LETTER OF SUBMITTAL
 KFM Skyway Project # 04-012024

Subject: USI - Documents Clearing USI WM NCR #36

PROJECT: SFOBB Skyway Structure

Subject: Responseto Caltrans State Letter # 5.03.01-006055, DTD 11/09/2004
KFM NCR # 36R1

Subject: Response to KFM-SUB-002328R00: USI - Heat Straightening Request 04-16 for Piece #56

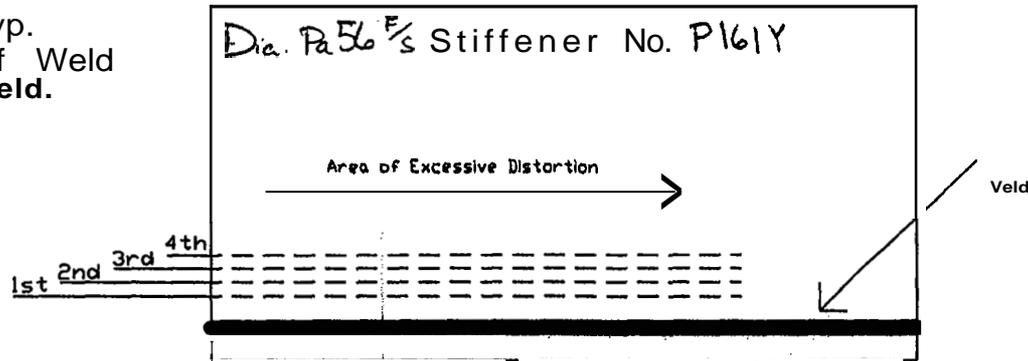
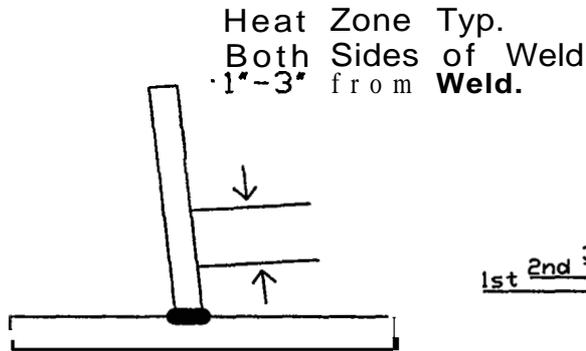
The State has reviewed KFM-SUB-002328R00: USI - Heat Straightening Request 04-16 for Piece #56 regarding the request to heat straighten stiffeners on diaphragm pa56. The subject submittal is approved as noted. The State will allow USI to apply one progression of heat in accordance with USI's "Typical T-Joint Weld Distortion Repair Procedure" to the following pieces: p161y, p161ab, p161b, p161g (1st from left), p161g (2nd from left), p161g (3rd from left), p161g (5th from left), p161g (6th from left), p161g (7th from left), p161k. Heat straightening should occur in the presence of a State QA inspector. After the first progression of heat is applied, the measurements of the affected dimensions should be communicated to the State QA inspector on the shop floor. At this time, the State may approve the second progression of heat in accordance with the "Typical Butt Weld Distortion Repair Procedure." Subsequently, non-destructive testing (NDT) shall be performed in accordance with AWS D1.5 Section 6.7.3.

TYPICAL T-JOINT WELD
DISTORTION REPAIR PROCEDURE.

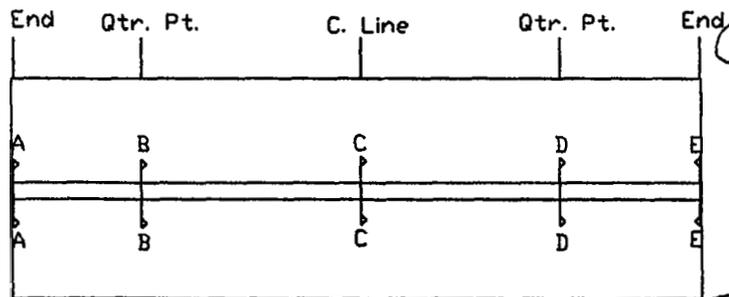
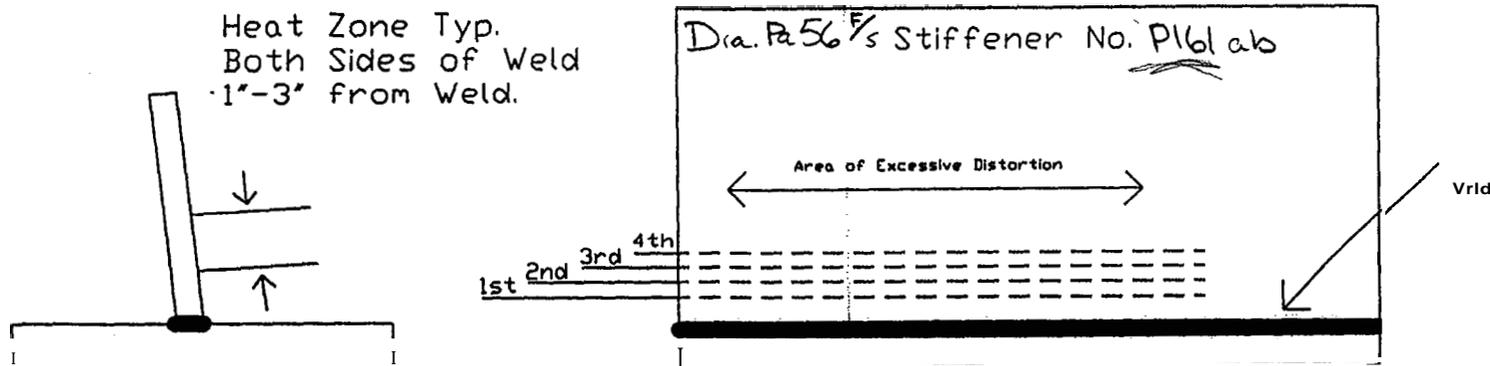
1. Line heats to **be** applied to full length of weld where excessive distortion is present
2. First line heat shall be placed nearest to the weld and progress away from the previous line of heat.
3. Each line heat **will** be applied to the stiffener side parallel to the weld and allowed to cool. Check Drior to application of next progress heats.

4. Our goal **is** to act eve acceptability in four progressions.
5. All deviations discovered in previous applications will be imptemented in conjunction with fabrication plan rev. 9. Deviations found in this NCR will be reviewed for **possible** corrections in the fabrication plan for future operations.

SECTION	DEVIATION FROM SQUARE					
End	Qtr. Pt.		Original Check	1st Heat	2nd Heat	3rd Heat	4th Heat	5th Heat
		Left end of Horizontal Stiffener						
		A-A	0mm					
		B-B						
		C-C	12 mm					
		D-D						
		E-E	8 mm					
		Right end of Horizontal Stiffener

Dia. R 56" Stiffener No. P1619
1st from Left

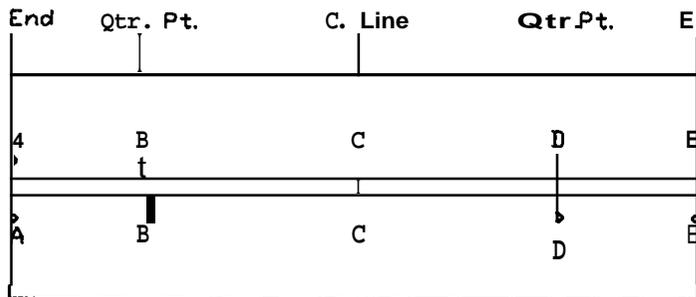
Area of Excessive Distortion

1. Line heats to **be** applied to full length of weld where excessive distortion is present
2. First line heat shall be placed nearest to the weld and progress away from the previous line of heat.
3. Each line heat will be applied to the stiffener side parallel to the weld and allowed to cool. Check prior to application of next progress heats.

SECTION	DEVIATION FROM SQUARE					
	Original Check	1 st Heat	2 nd Heat	3 rd Heat	4 th Heat	5 th Heat
<i>Bottom of vert. stiffener</i> A-A	7mm					
B-B						
C-C	4mm					
D-D						
E-E	2mm

ONE ~ DIAPHRAGM ASSEMBLY ~ p085

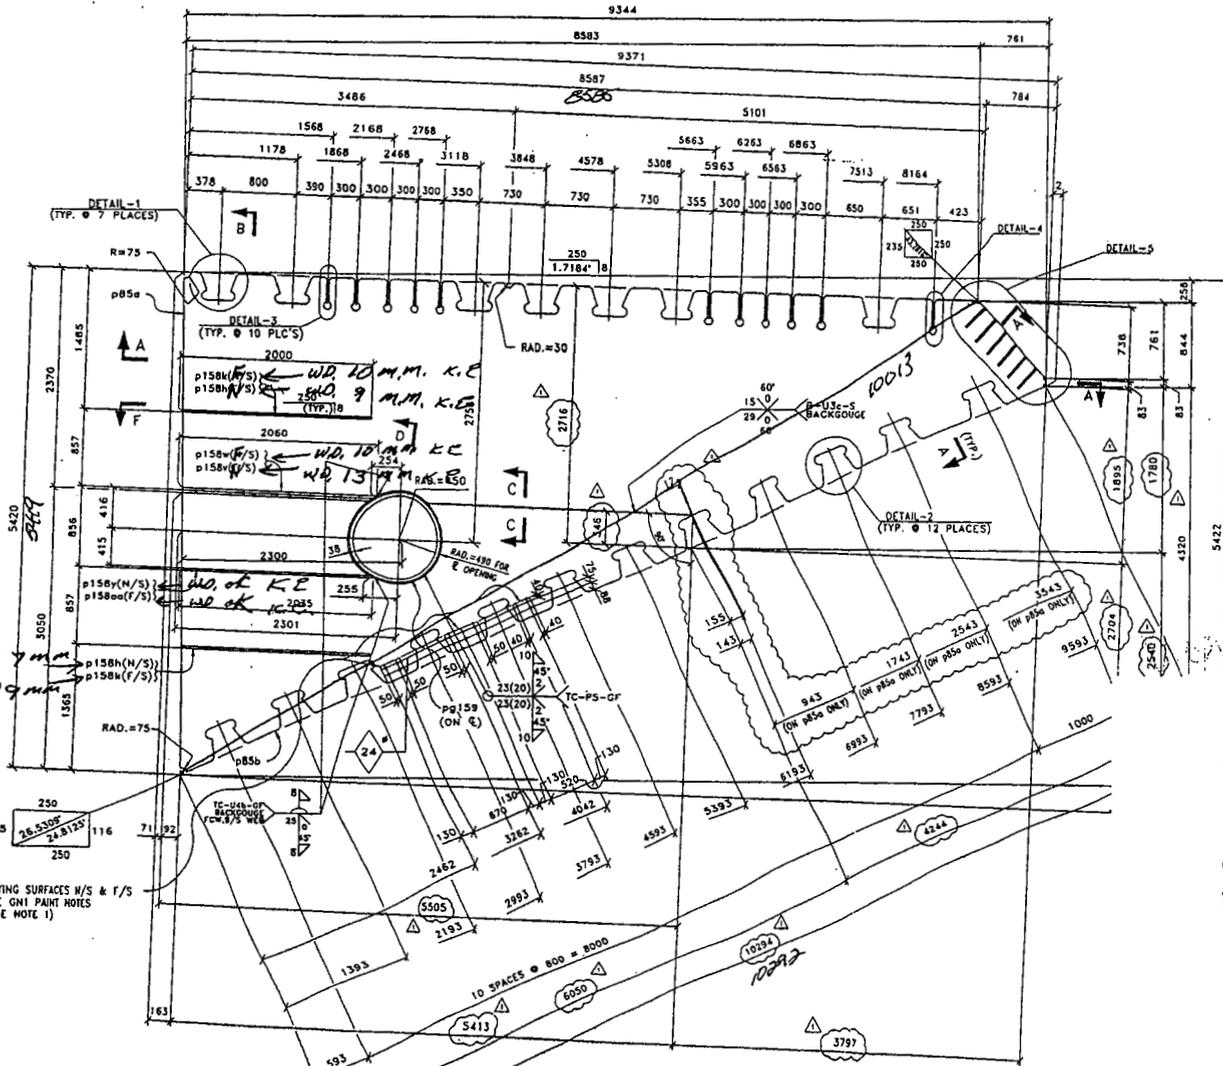
CHECK #1 of ~~Weld~~
 CHECK #2 Comp. JPS (NCR #2 - DISCREPANCY AT SPICE 5 FEET)
 CHECK #3 of JPS
 CHECK #4 of JPS - STIFFENERS & RING

Check #2 - Record overall dimensions, crosschecks and any out of tolerance flatness.
 Inspector Jon Smitherman Date 3-17-04
 Accept Reject NCR#(s) 4-27-04

Step 1 - Details of Non-conformance:
wing diaphragm Pa 85 weld distortion in Butt splice
variation is between 5 + 8 m.m. either side of
access Penetration.

Responsible Department: _____ Department Supervisor _____
Step 2 - Corrective Action: Engineer approval required: yes no
APPCY controlled Heat to Flatten PC
